# Divine Textiles Ltd

Pollibiddut, Shafipur, Gazipur, Dhaka  
(24.03977N, 90.25669E)

22 March 2014

# Observations

## Management of Storage Loads

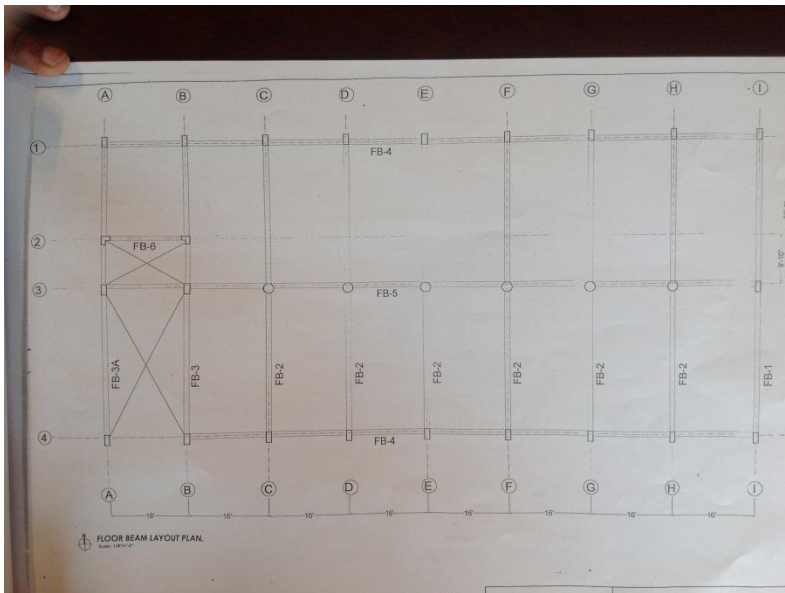
8 storey building - 4<sup>th</sup> Floor Storage Area

Uncontrolled stacking of material

8 storey building - Ground Floor Storage Area

Building Engineer to prepare controlled loading plans for all floors which will designate where storage can be placed.

8 storey building typical plan

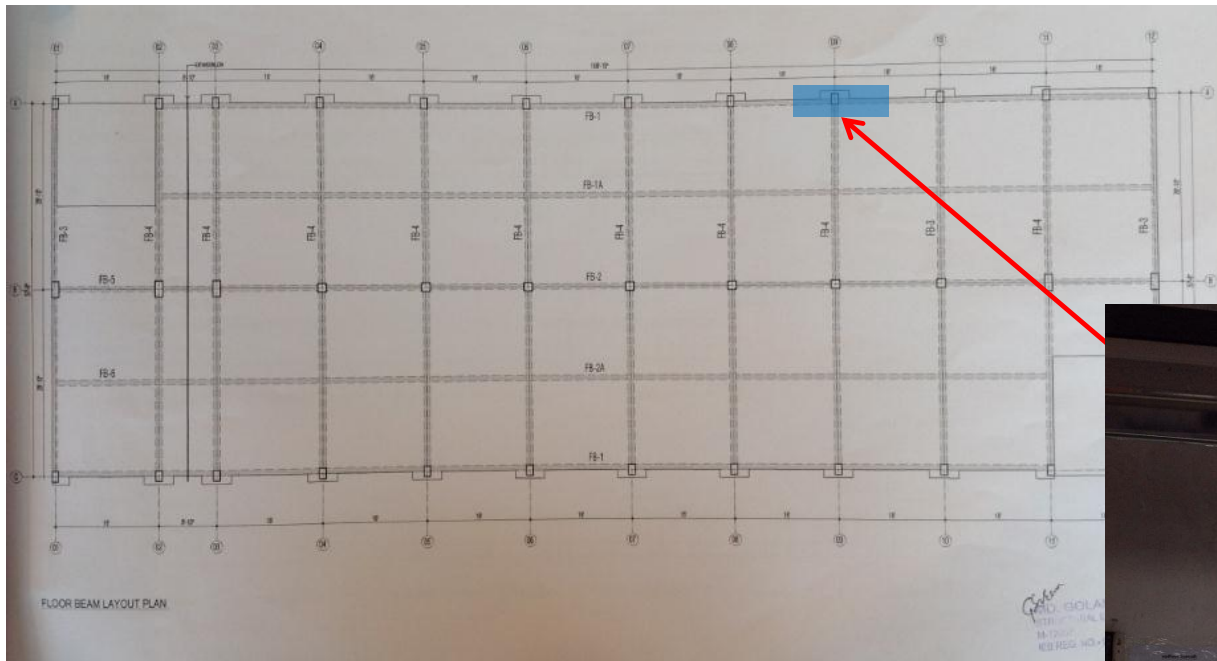
# **Inconsistencies between structural drawings and the as-constructed arrangement of the factory**

Longer grid dimension is 8.9 m (29' 2'') and not 8.53 m (28')

Steel structures at roof level on 4 and 6 storey buildings are not shown on structural drawings.

Building Engineer to survey as-built structure and update drawings.

## Water ingress

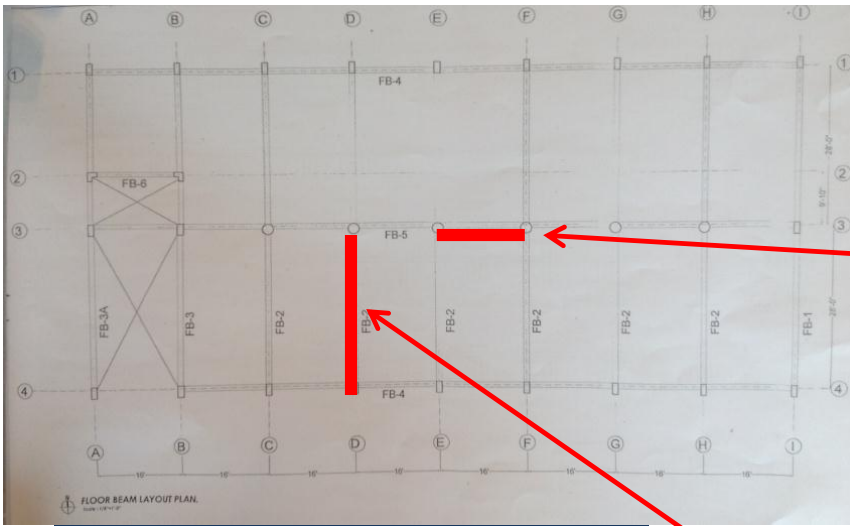
Water ingress on 4<sup>th</sup> floor of 6 storey building

**Areas where water ingress is evident should be investigated and the cause of such should be remedied.**
